NOTICE TO CONTRACTORS
BID #1314-134
Fuji Park/Fairgrounds Maintenance Building
PWP # CC-2014-071

Jan. 17th, 2014

Addendum No. 2

**FUJI PARK / FAIRGROUNDS
MAINTENANCE BUILDING
601 OLD CLEAR CREEK ROAD
SITE PLAN**

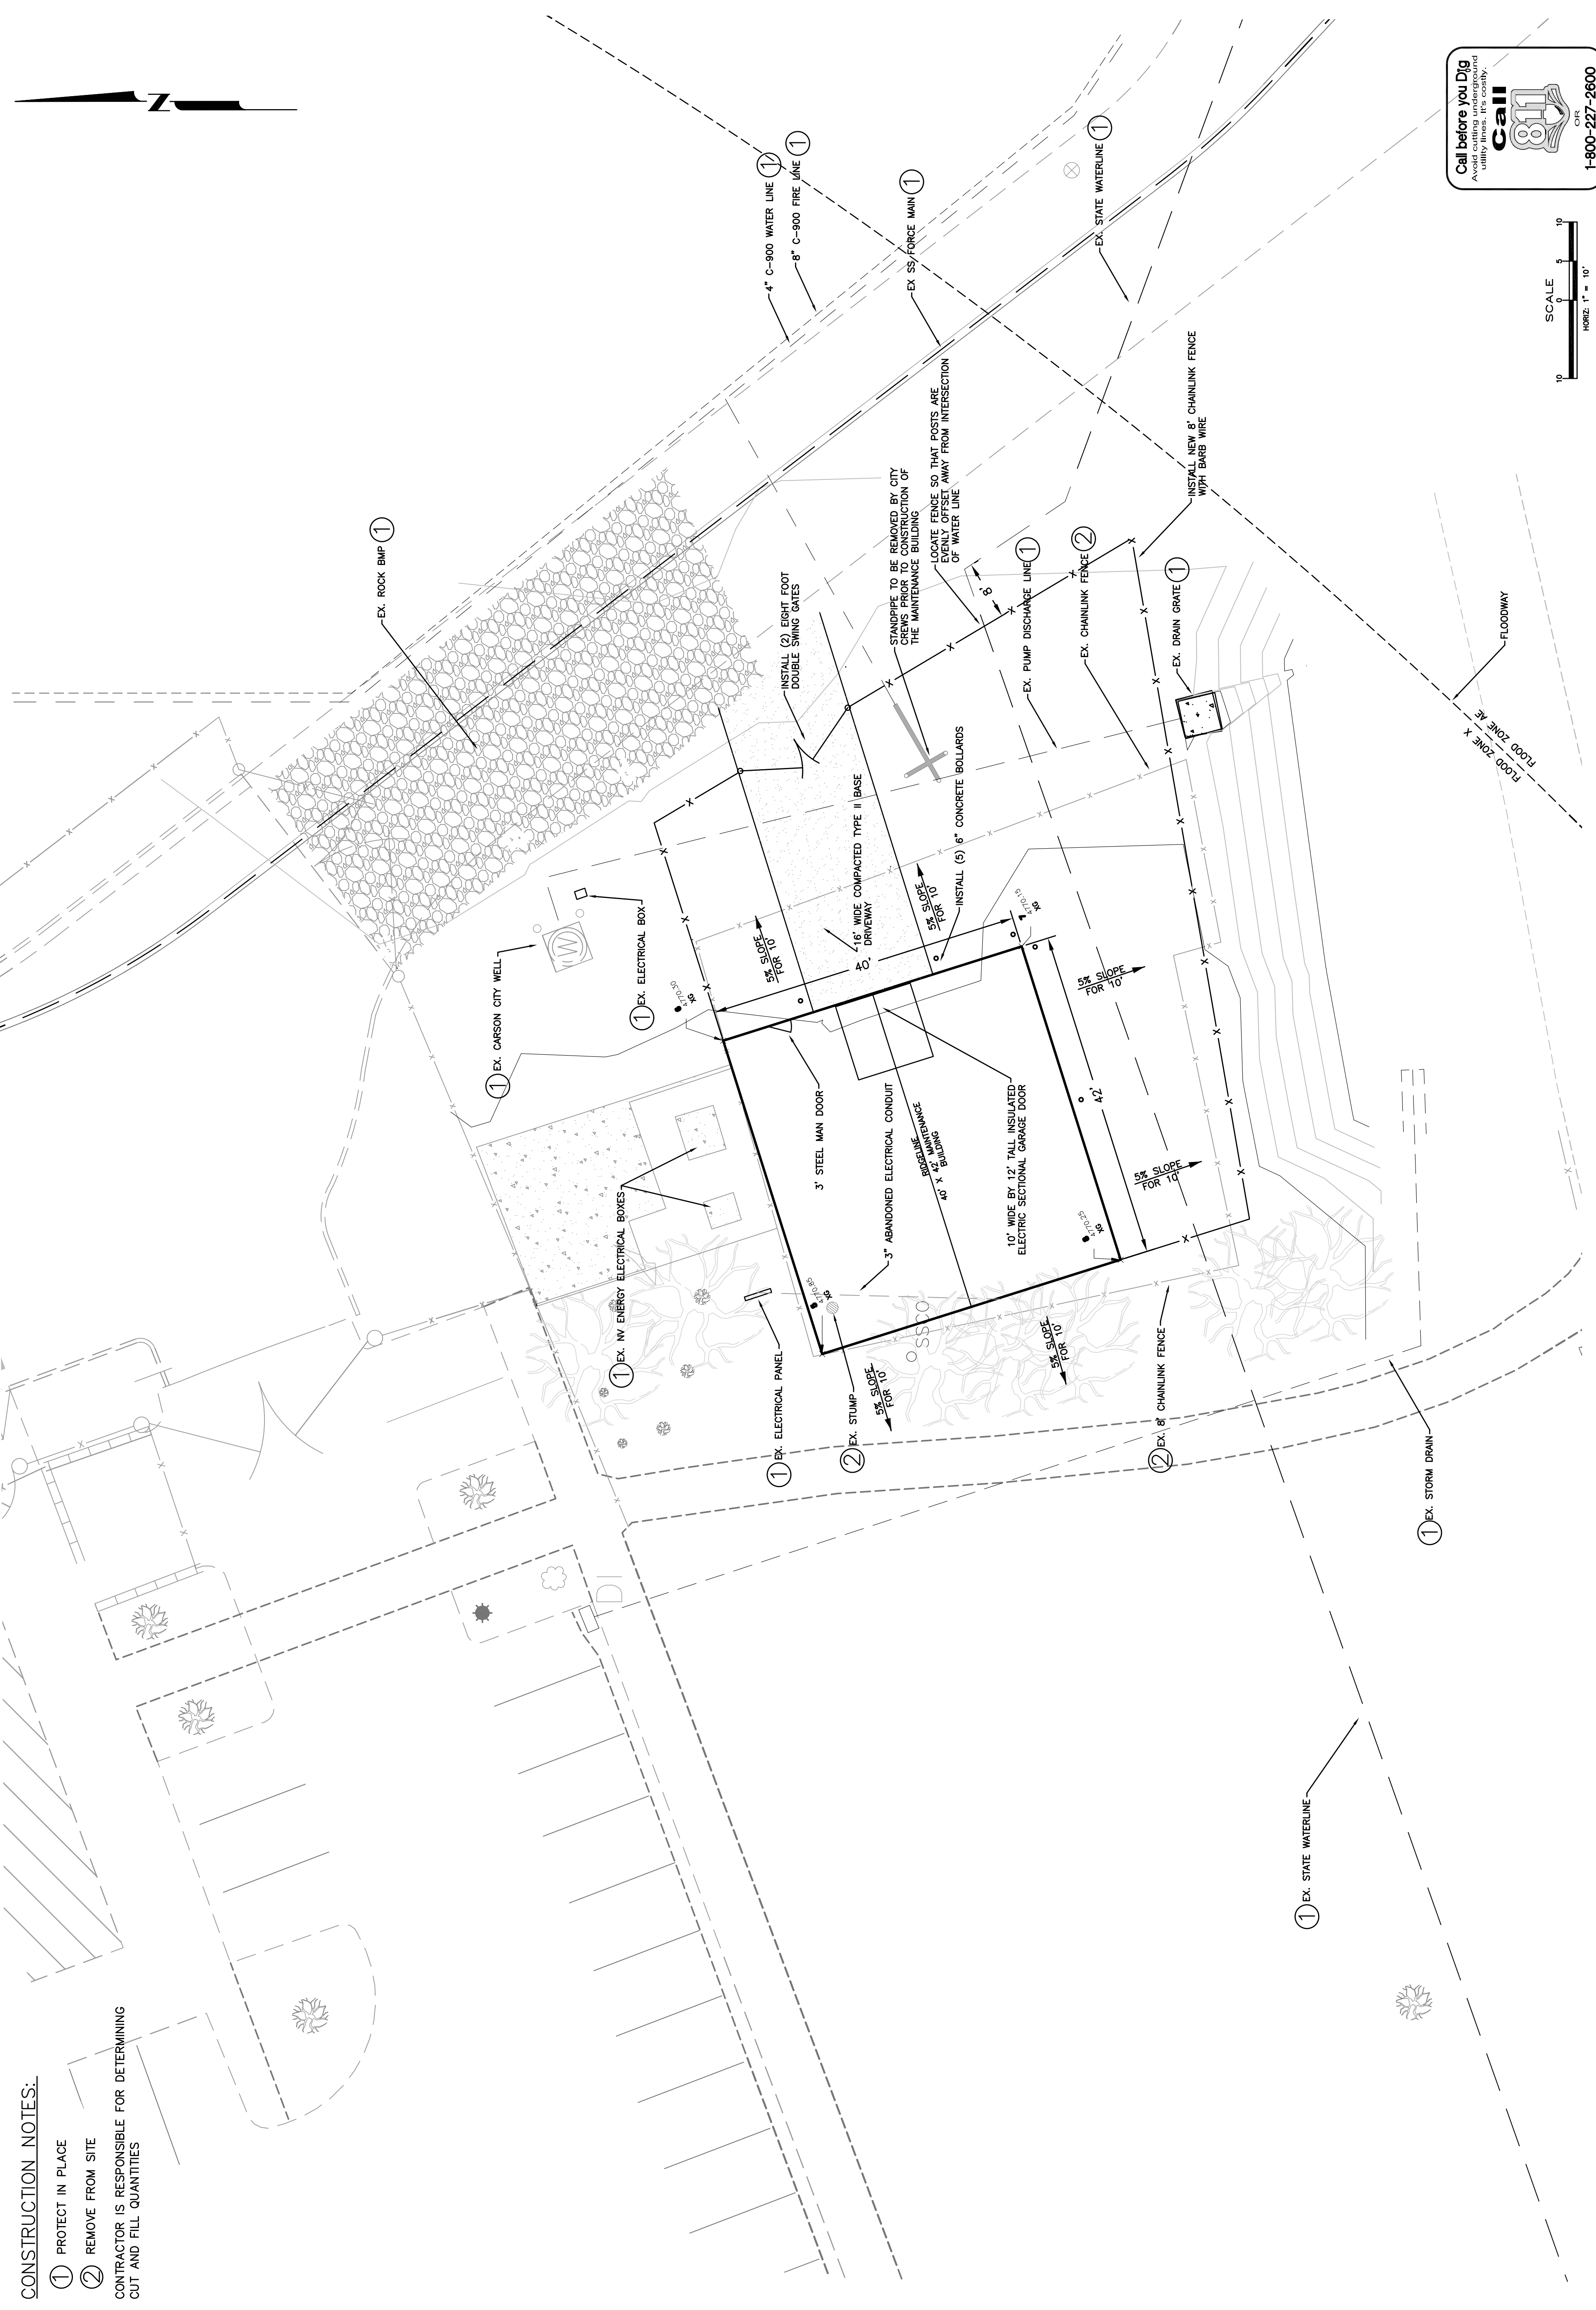
Replace sheet C3.0 of the plans for the attached revised sheet C3.0 showing existing grades at the four corners of the new maintenance building.
